VALUE ENGINEERING STUDY

Project # STP00-0198-01(020) PI No. 132610-

SR60 Widening & Reconstruction in Murrayville
Hall County, Georgia

23 June 2011

R-10.0 Typical Use of Corrugated Median

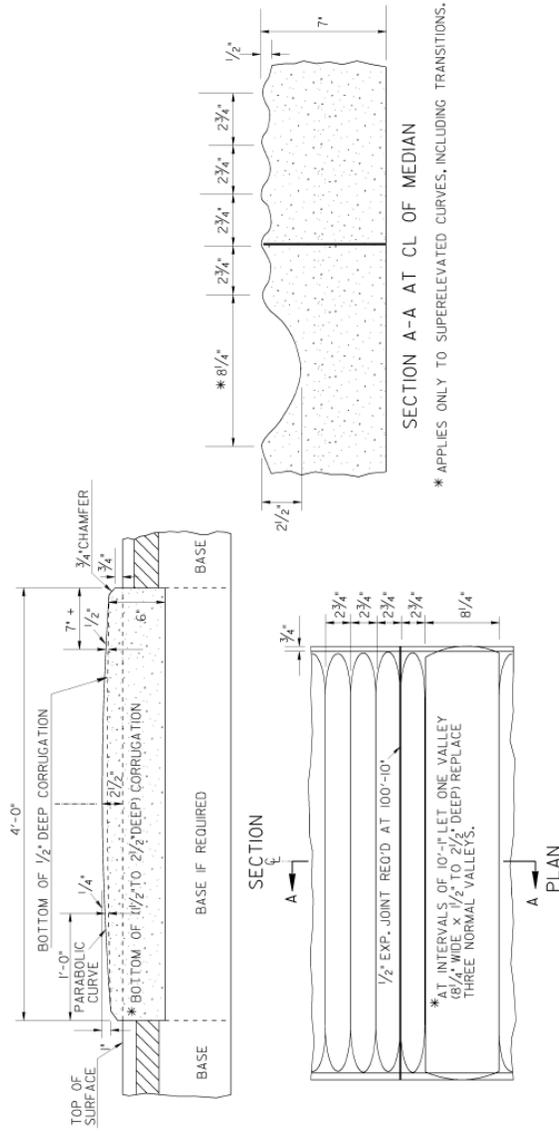
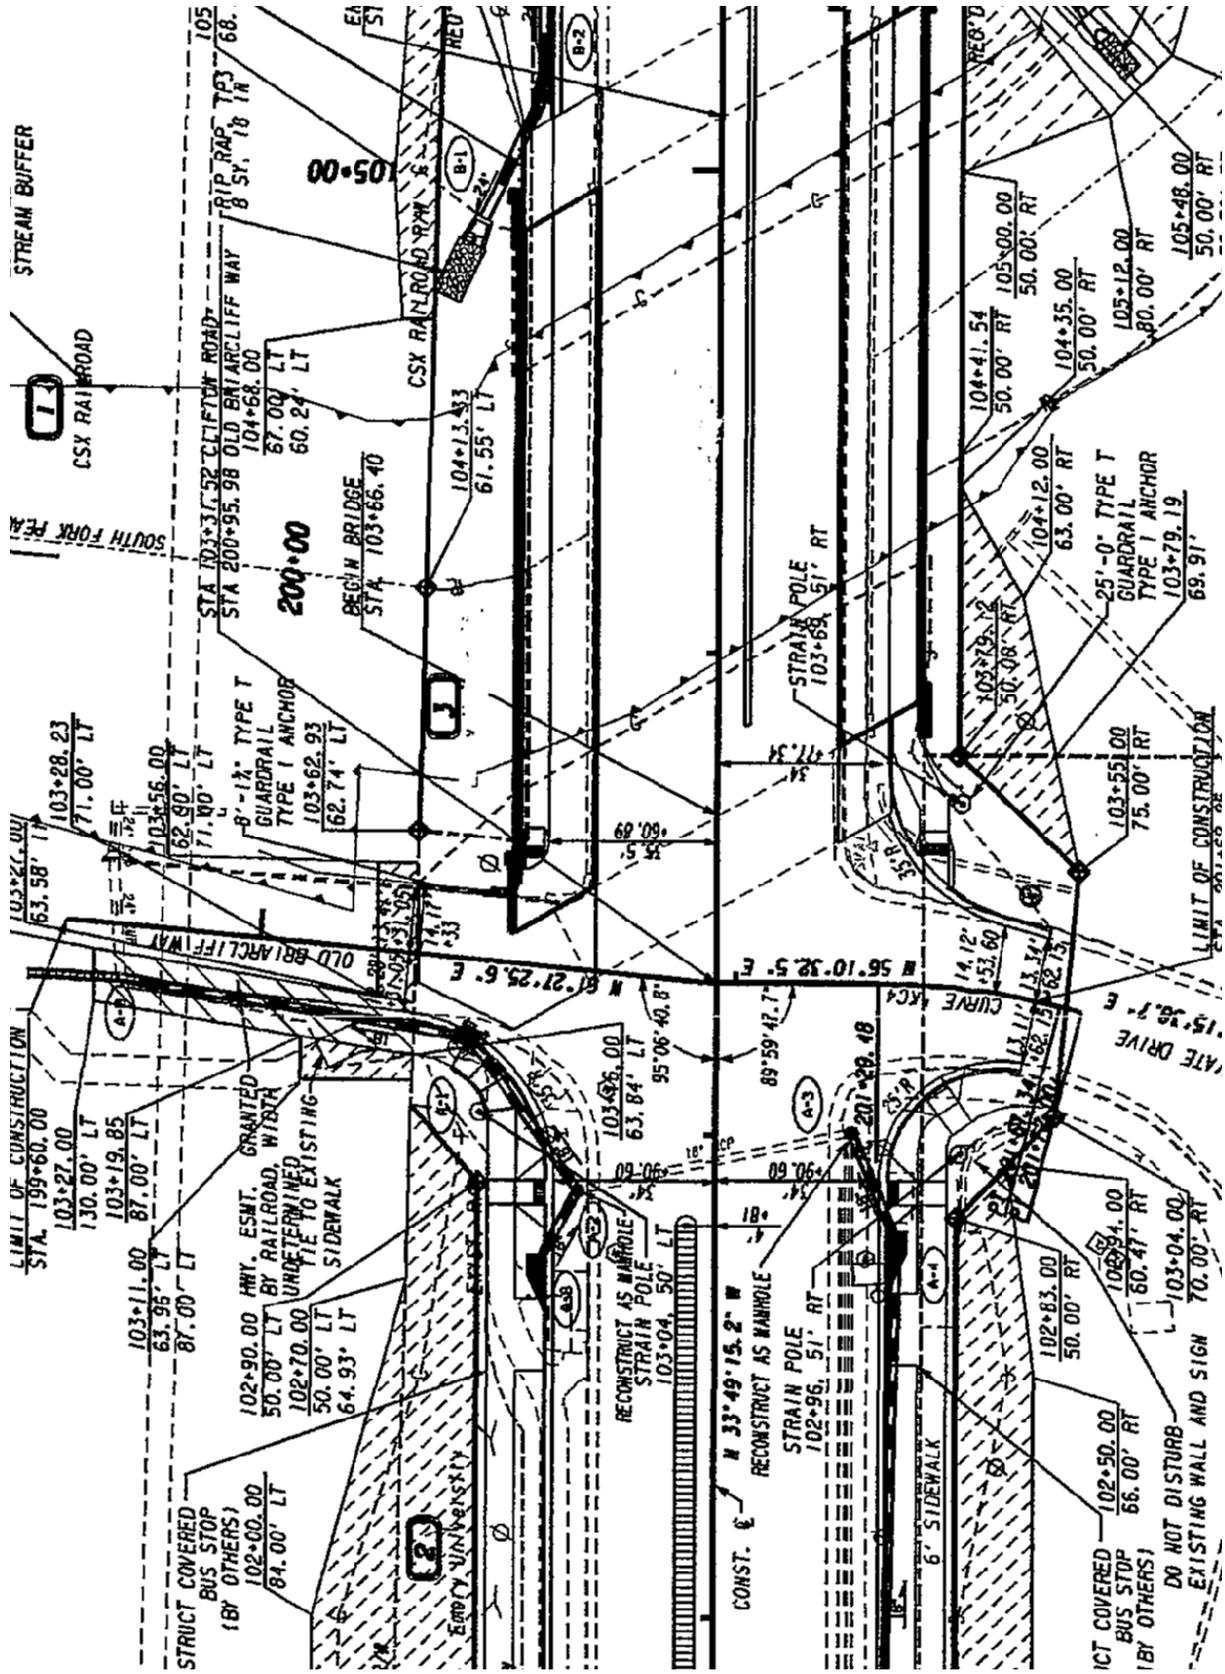
PROPOSED CHANGE: The proposed recommendation is to construct a corrugated concrete median (standard detail) in lieu of the raised concrete median.

JUSTIFICATION: Proposed change facilitates drainage across the roadway and eliminates need for gutter inlets in the median area, while also providing a savings in construction costs.

R-13.0 Proposed Change 1 of 1

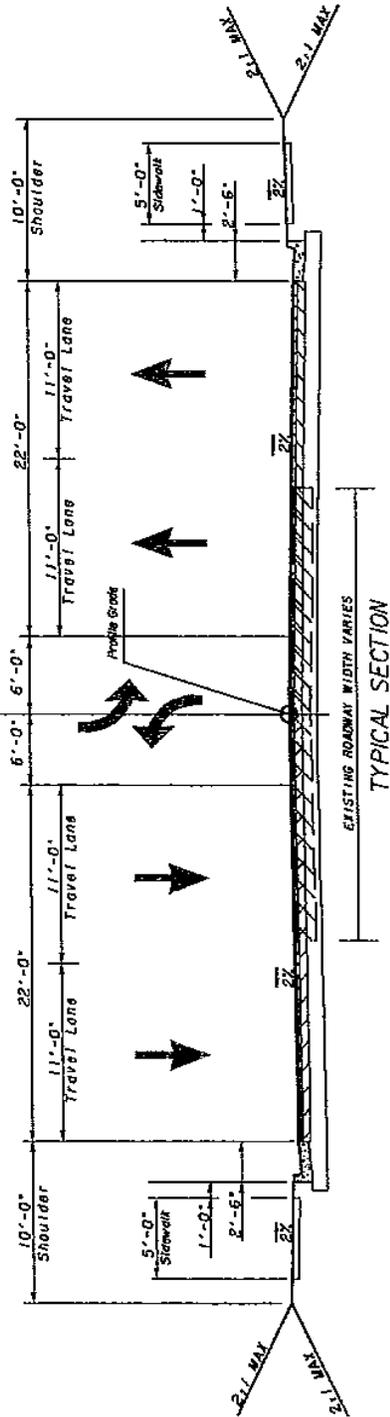
PROPOSED CHANGE: The proposed recommendation is to revise the typical section to four 11-foot travel lanes with a 12' flush center turn lane. The median will still be reduced to 6' in critical areas. (Sta. 48+50 to 60+50 and Sta. 158+85 to 173+50). Keep right of way corridor at 100 feet.

R-14.0 Proposed Change

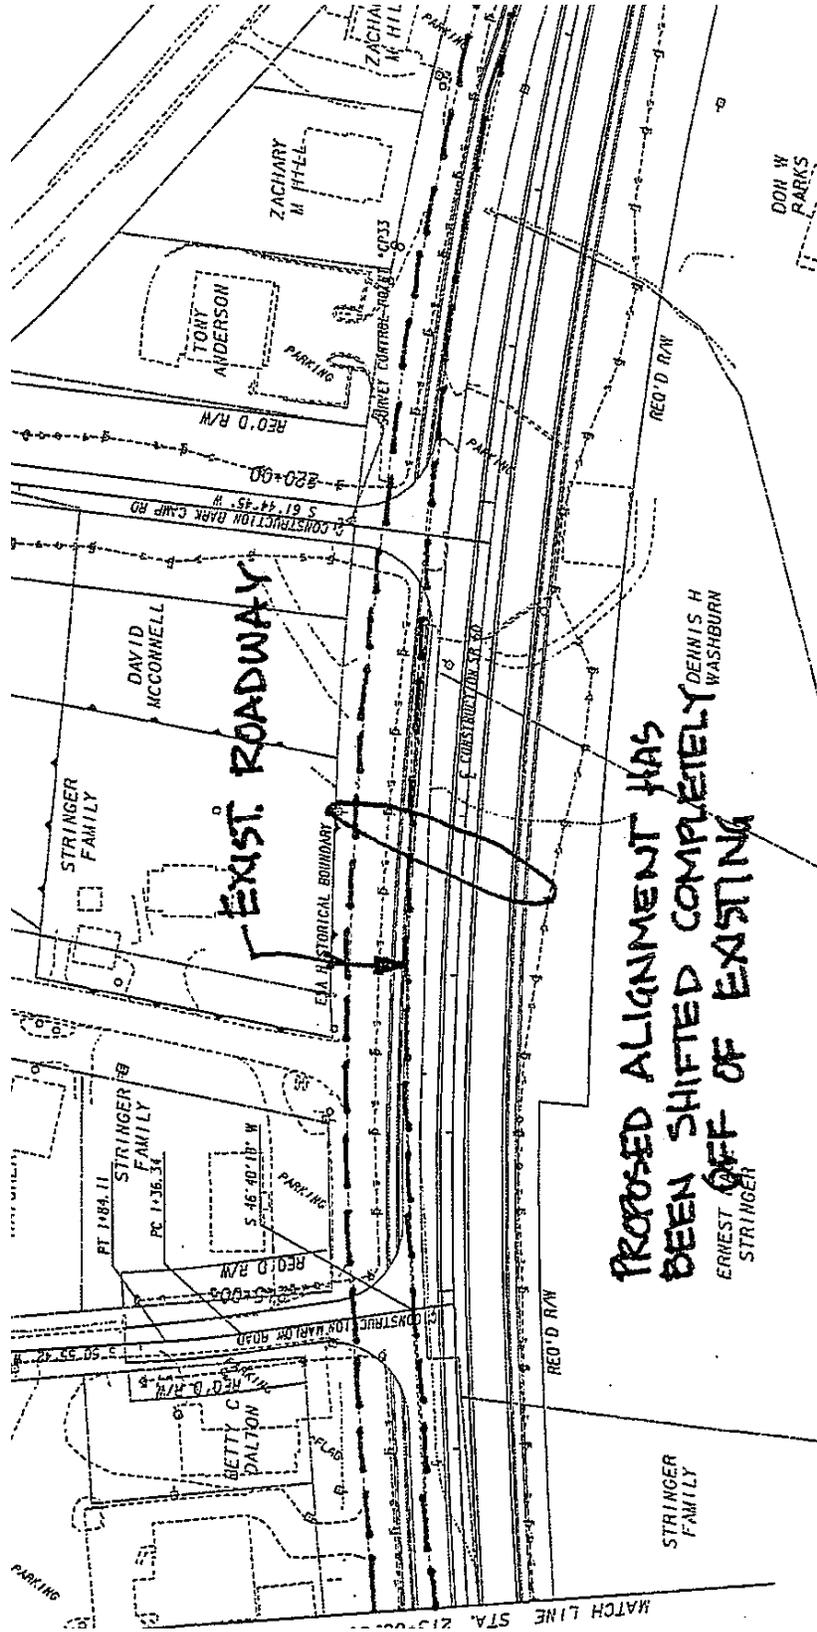
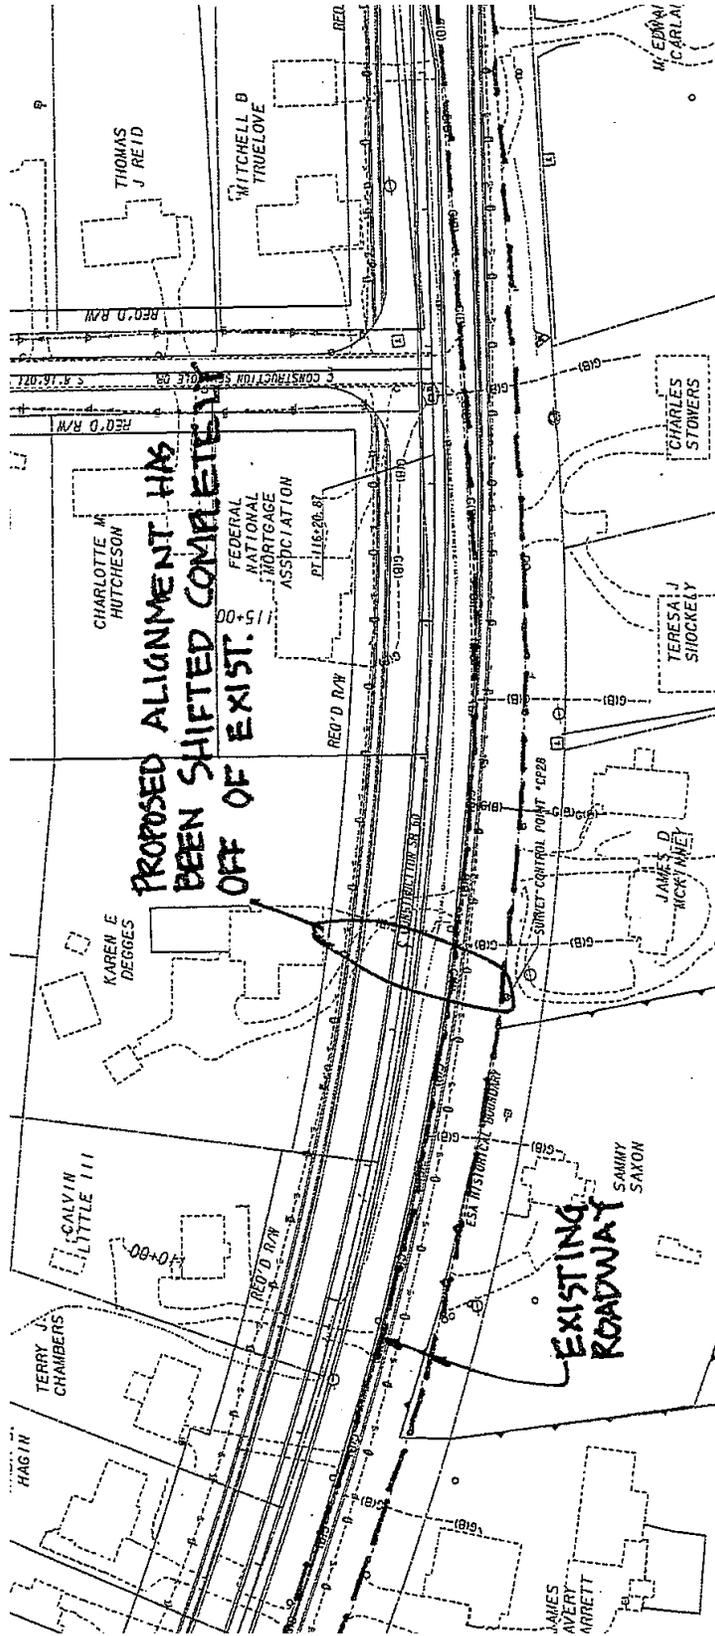
PROPOSED CHANGE: The proposed recommendation is to redesign and maintain existing alignment for roadway Sta. 100 + 00 to 124 + 00 and Sta. 208 + 00 to Sta. 234 + 00. This will avoid condemning (acquiring) a minimum of 4 properties, and as many as 6 properties.

R-21.0 Current Design 1 of 1

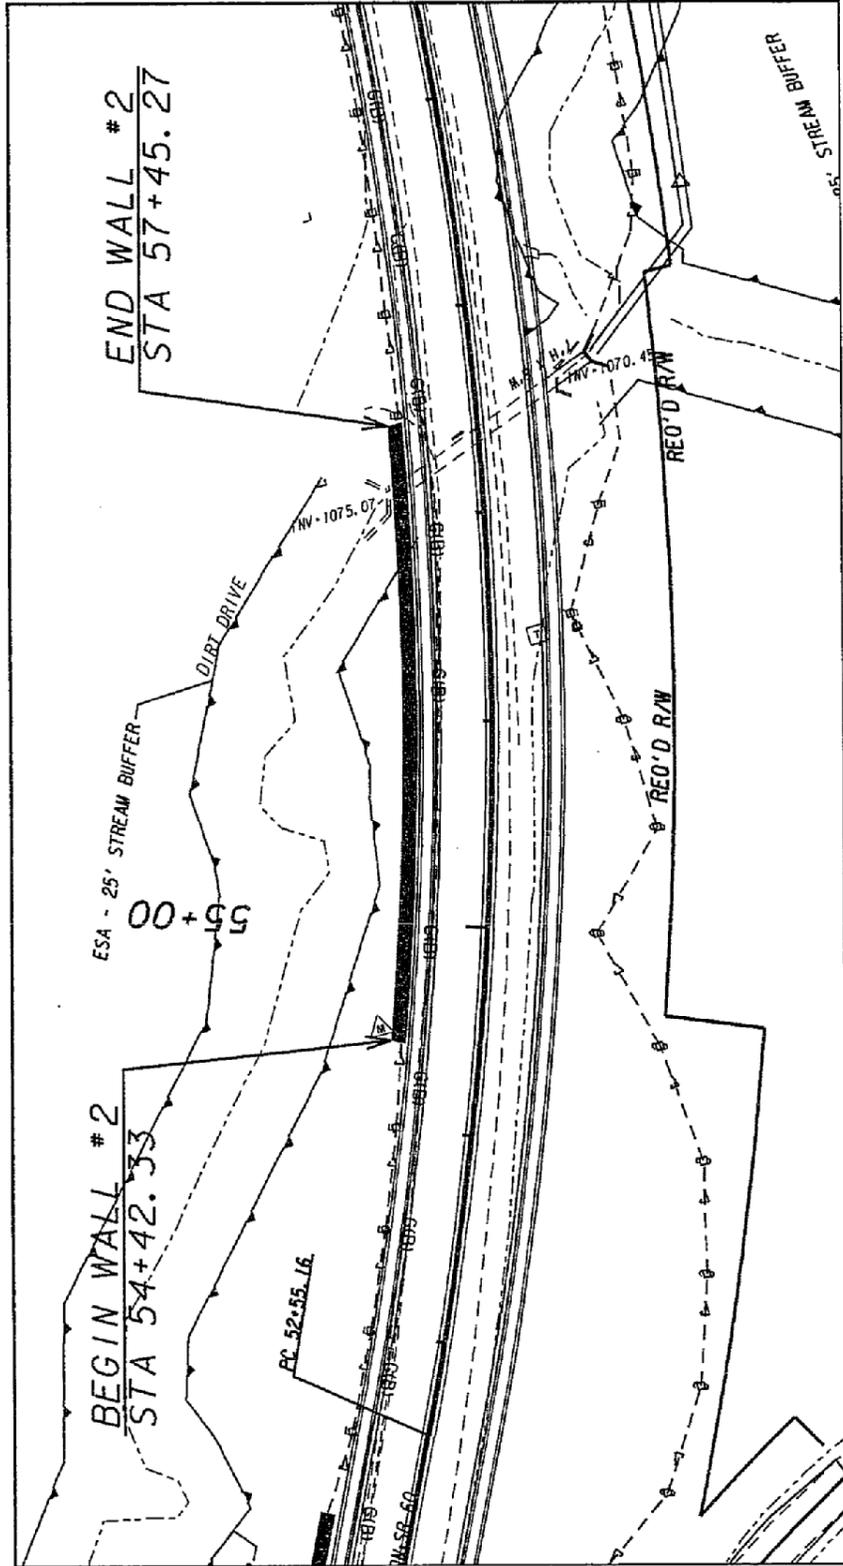
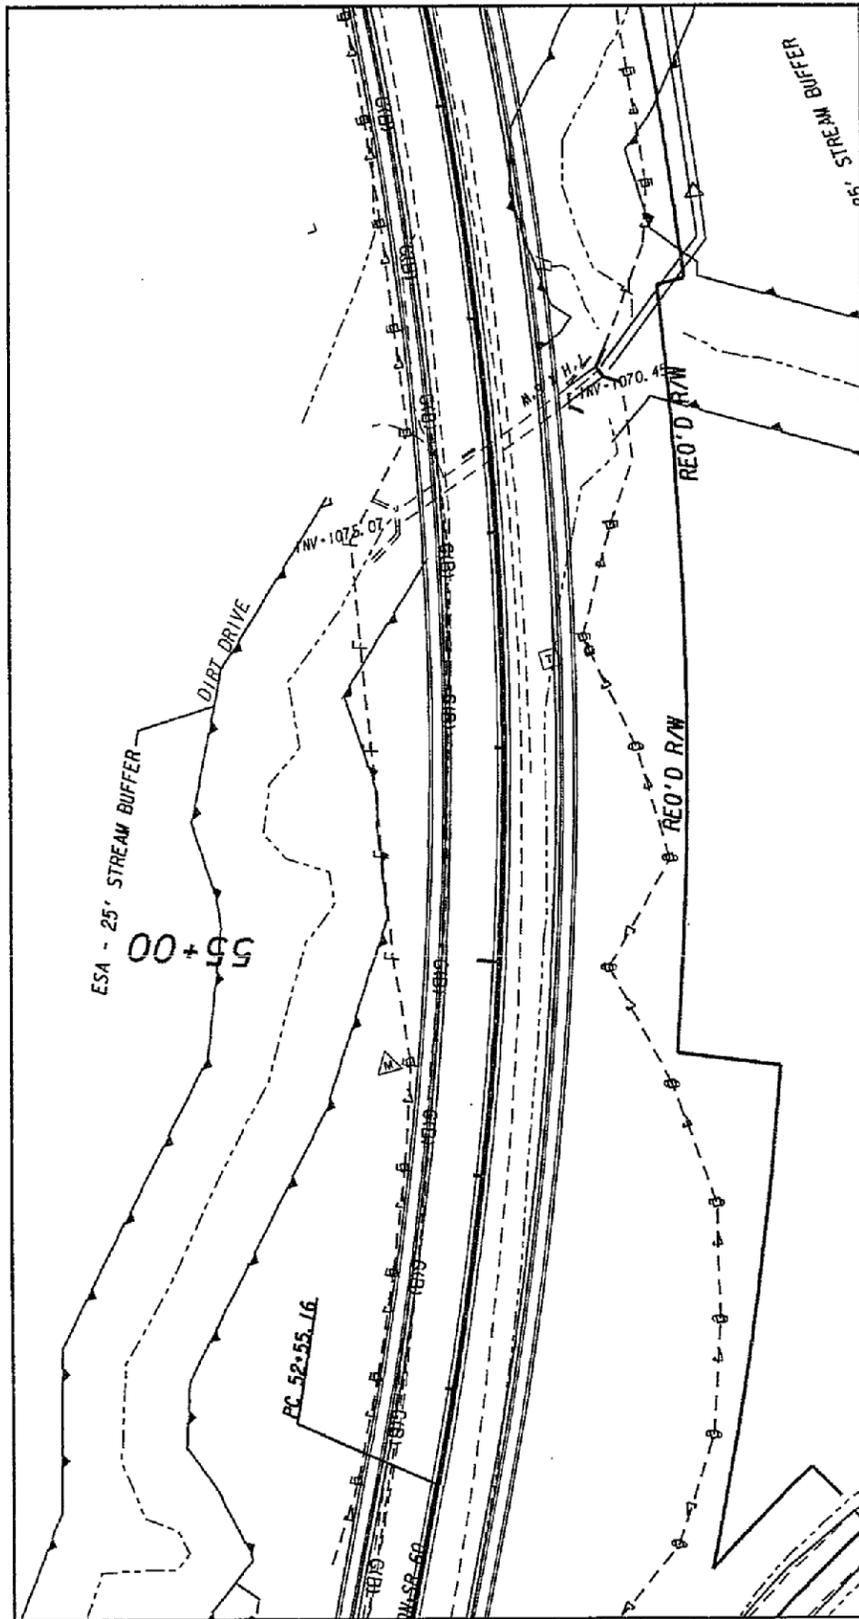
ORIGINAL DESIGN: In the current design a retaining wall is proposed from Sta. 54+42 left to Sta. 57+45 left to avoid stream buffer impacts to flowing drainage ditch. (The type and height of wall is not provided in the plans and wall is not shown on the cross sections.)

PROPOSED CHANGE: The recommendation is to eliminate the proposed 303' wall, and construct fill slopes as per the proposed typical section. Also extend the existing 7' x 6' RCBC at Sta. 57+50+/-.

JUSTIFICATION: Placement of fill in lieu of constructing a wall would only impact the stream buffer an estimated 200 feet at this location and would save the construction cost of the wall. According to the current plans, this culvert is being extended on the east side and the stream is being relocated.
